Monticello Nuclear Generating Plant
Operated by Nuclear Management Company, LLC

Monticello Extended Power Uprate (USNRC TAC MD8398):
Acceptance Review Supplemental Information Package 4

Reactor Inspection Branch Questions and Responses

Figure 1 - Dose Rate as a Function of HWC Injection Rate (Typical)

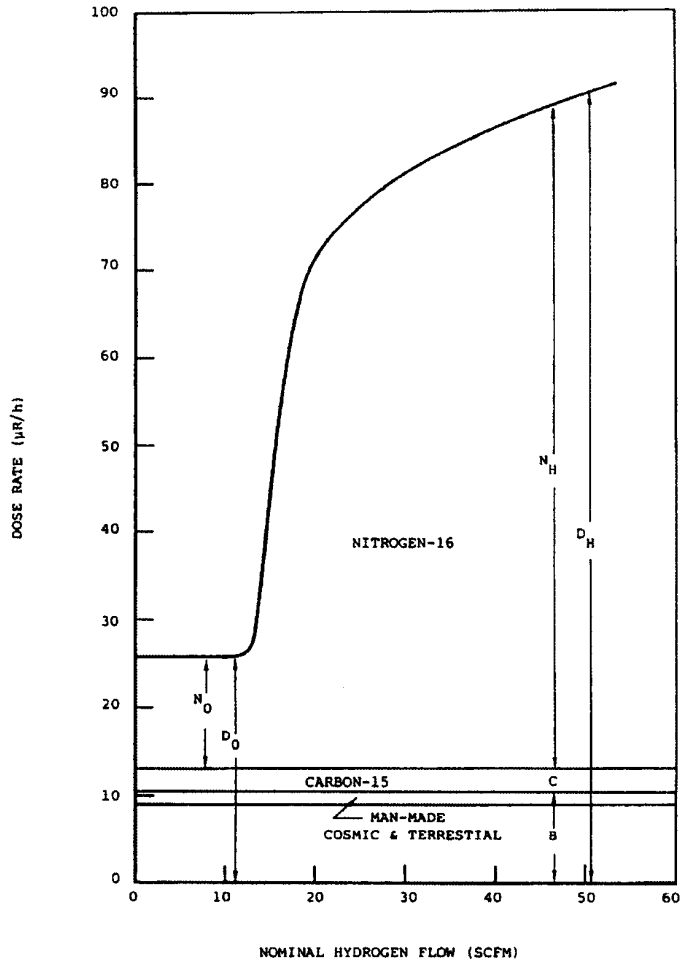
NRC Question 3)
Describe the contribution and effects of hydrogen water chemistry (HWC) (N-16) to the radiation doses (both pre-EPU and post-EPU) to members of the public onsite.

Table 9 - Effects of HWC		
Item	**Assumption**	**Ref./Basis**
1	The increase in skyshine dose rate at EPU conditions is driven by N-16.	N-16 is the predominant radiation source in BWRs, especially in plants with HWC. N-16 production rate increases in proportion to the increase in thermal power (approximately 13%). At a constant HWC injection rate the feedwater hydrogen concentration entering the reactor would decrease slightly. However, this effect is offset by the increase of radiolysis which produces free hydrogen from the reactor coolant. The increase in steam flow at EPU (14.8%) offsets this increased N-16 production by dilution. So N-16 concentration in steam exiting the RPV at EPU (without an increase in HWC Injection rate) would remain constant. Increased steam flow rates decrease transit time for N-16 in steam to various points in the BOP. This reduction in transit time allows less time for decay of N-16 and results in increased radiation levels further downstream in steam piping and steam systems.

2	HWC injection rate will be increased by approximately 14.8% (the EPU increase in feedwater flow rate) to maintain feedwater hydrogen concentration at current levels.	Reasonable assumption, based on design basis for HWC. No actual increase has been planned or identified at present.
3	The dose rate due to N-16 increases linearly with the increase in hydrogen injection rate.	EPRI Report NP-4621 (See Figure 1 below) shows the typical characteristic response of steam radiation levels with increasing hydrogen injection rate. MNGP radiation operating hydrogen injection levels place the plant in the upper region of this curve where it is conservative to predict a linear increase in radiation levels with increasing injection rate.

Table 9 - Effects of HWC		
Item	**Assumption**	**Ref./Basis**
4	Plant Skyshine from the Turbine	The primary source of skyshine is the N-16 gamma in reactor steam in the turbine building. The shine from piping and components above grade will only be attenuated by equipment materials, shielding and building materials. The skyshine dose for equipment below grade will be also be attenuated by the earth around the turbine building. In general the changes in the equipment above grade will be the most significant factor in skyshine although radiation scatter from other sources may be present. The equipment above grade includes steam piping, turbines, feedwater heaters, the upper portions of moisture separators and the transition between the turbines and condenser. A conservative estimate of the impact of EPU on skyshine is based on the increase in N-16 dose as a function of increased injection rate times the change in dose due to changes in steam transit time. Using 14.8% increase in feedwater flowrate to estimate increased hydrogen injection rate and the effect of transit time at the exit of the #15 FWH (17.1% increase in estimated dose rate) yields a maximum skyshine source dose rate increase of 34.4% (1.148*1.171).
